Development Services Staff Report

File Number	PL2025-274
File Name	PRELIMINARY DEVELOPMENT PLAN – 150 & Ward Apartments
Applicant	Milhaus
Property Address	3620 SW Ward Rd.
Planning Commission Date	December 11, 2025
Heard by	Planning Commission and City Council
Analyst	Adair Bright, AICP, Senior Planner

Figure 7 – Typical “Building A” (side elevation)

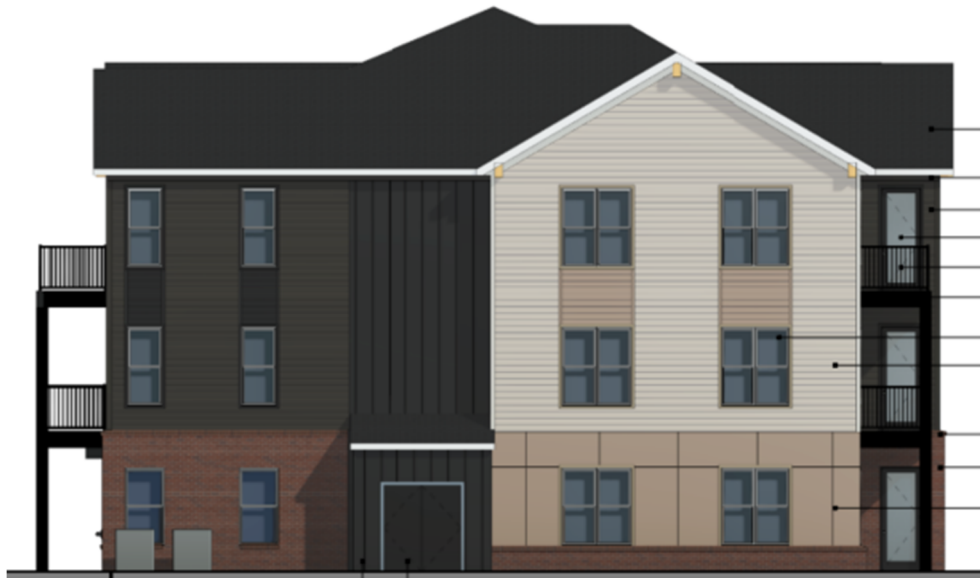
3. The applicant has requested a modification to UDO Sec. 5.510.B.4.c(6) pertaining to building design as required by the M-150 CDO. Staff has reviewed the request and supports the modification for the reasons identified below.

- **Requirement** – At least 20 percent of all walls facing a public street shall contain windows or doorways.
 - **Proposed** – Due to the orientation of the buildings and the site having a street on three out of the four sides, the side elevations of building types A, B, and C will face the street and have less than 20% windows or doorways.

- **Staff Recommendation** – Staff is supportive of the proposed modification since the intent is to ensure street-facing facades include a mix of materials and variation. The street facing facades use five different materials including the windows and doorways. On average, the street-facing facades of buildings A, B, and C will have 11%-17% containing windows or doorways.

Figure 8 – Site Plan showing property lines and existing right-of-way (property line shown in thick dashed line)

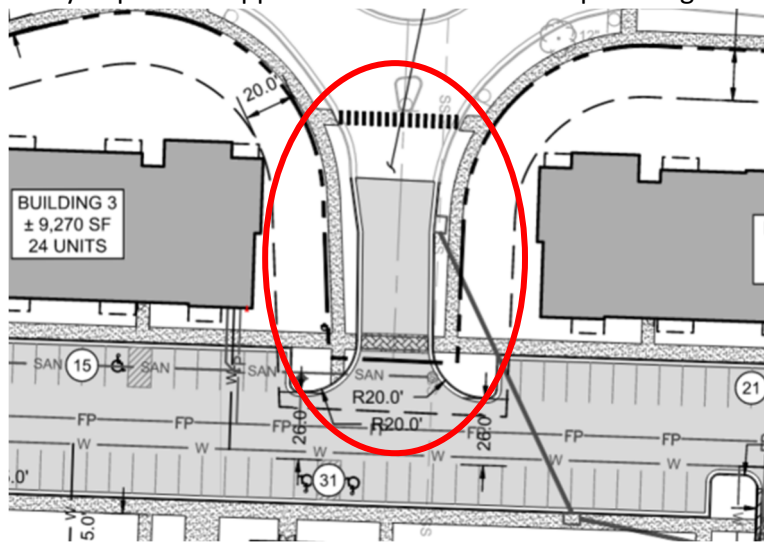
4. The applicant has requested a modification to UDO Sec. 8.620.B.1 pertaining parking lot setbacks. Staff has reviewed the request and supports the modification for the reasons identified below.
- **Requirement** – All parking lots shall be set back a minimum of 20 feet from any public right-of-way or private street edge of pavement.
 - **Proposed** – The applicant is proposing to reduce the parking lot setback adjacent to the right-of-way for the SW Arborwalk Boulevard roundabout from the required 20-ft. to 0-ft.
 - **Staff Recommendation** – Staff is supportive of the proposed modification due to how far the right-of-way cuts into the proposed site. The right-of-way extends 60-ft. south into the site from the edge of pavement of the roundabout. Approval of the modification is not anticipated to negatively impact the appearance of the site from public right-of-way.

5. A modification shall be granted to UDO Sec. 8.620.B.1 to reduce the required parking lot setback adjacent to the right-of-way for the SW Arborwalk Boulevard roundabout from 20-ft. to 0-ft.
6. A 5-ft. wide ADA-compliant sidewalk shall be constructed along the SW Arborwalk Boulevard frontage.
